HIGHWAY 24 EASTGATE BUSINESS PARK

A CONDOMINIUM PLAT OF LOT 3, HILLCREST ACRES
EL PASO COUNTY, COLORADO

BUILDING NO. 3

Plat_V1.pdf Markup Summary

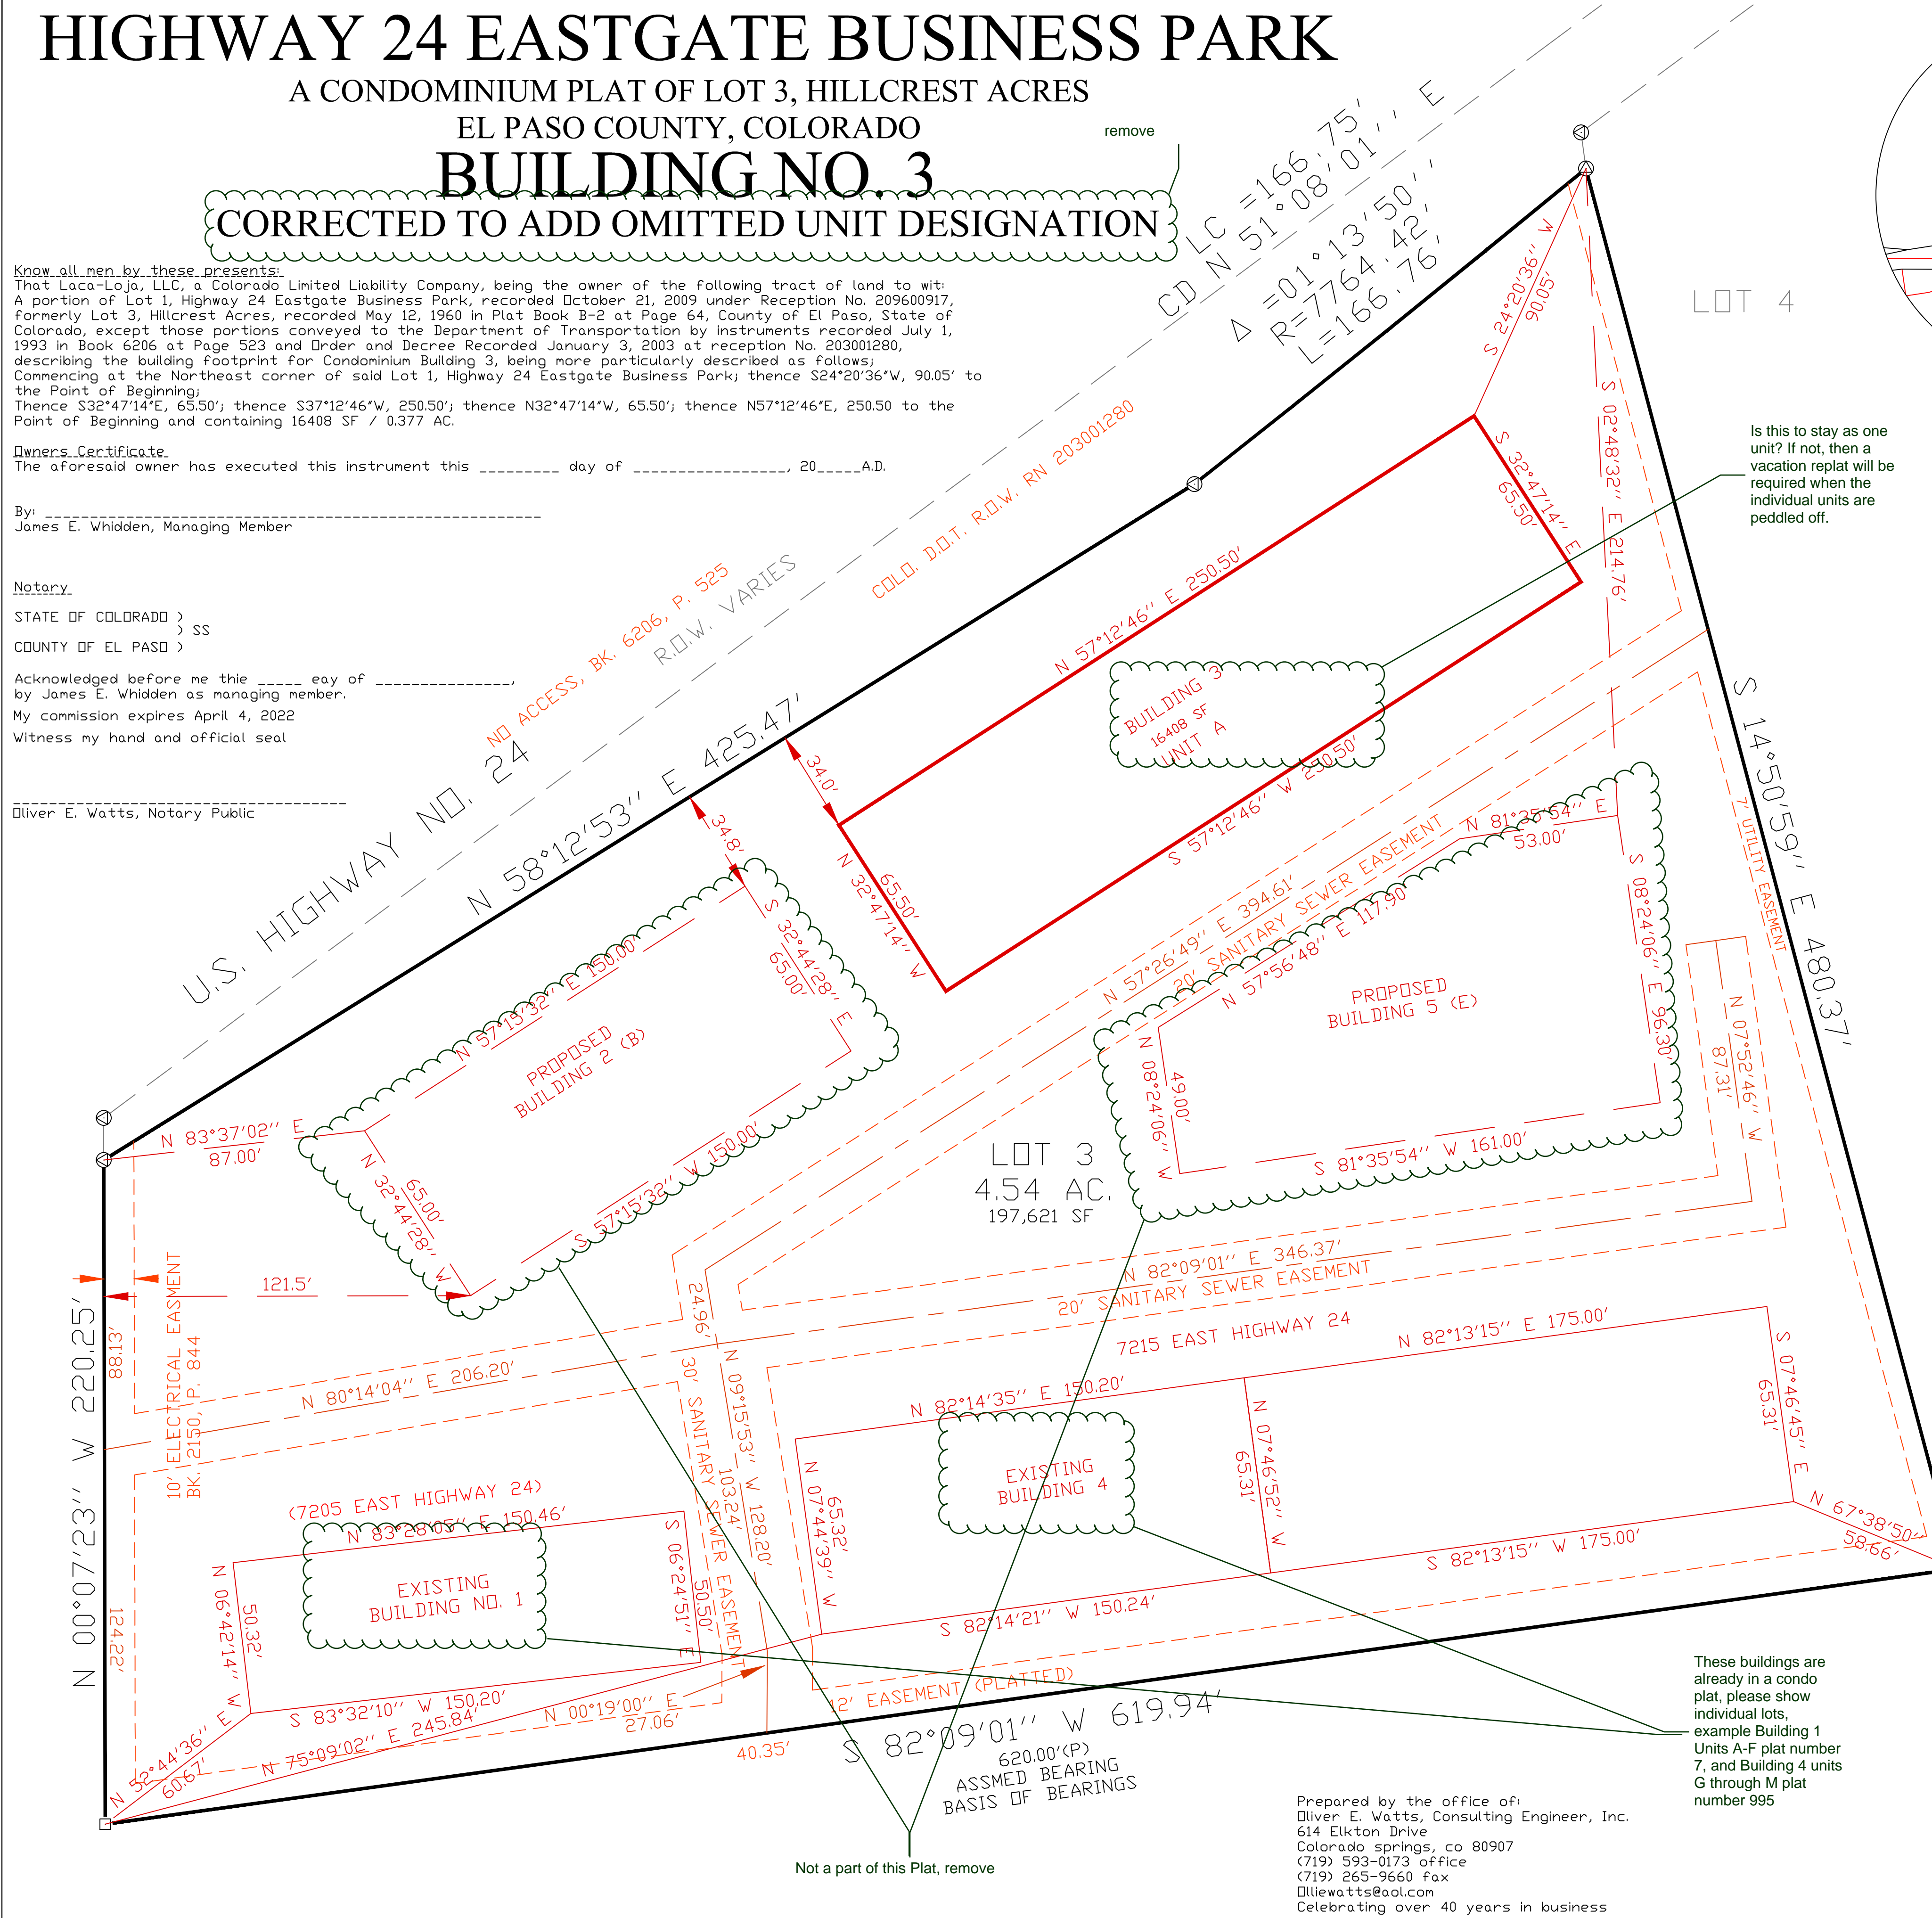
These buildings are already in a condo plat, please show individual lots, example Building 1 Units A-F plat number 7, and Building 4 units G through M plat number 995

Is this to stay as one unit? If not, then a vacation replat will be required when the individual units are peddled off.
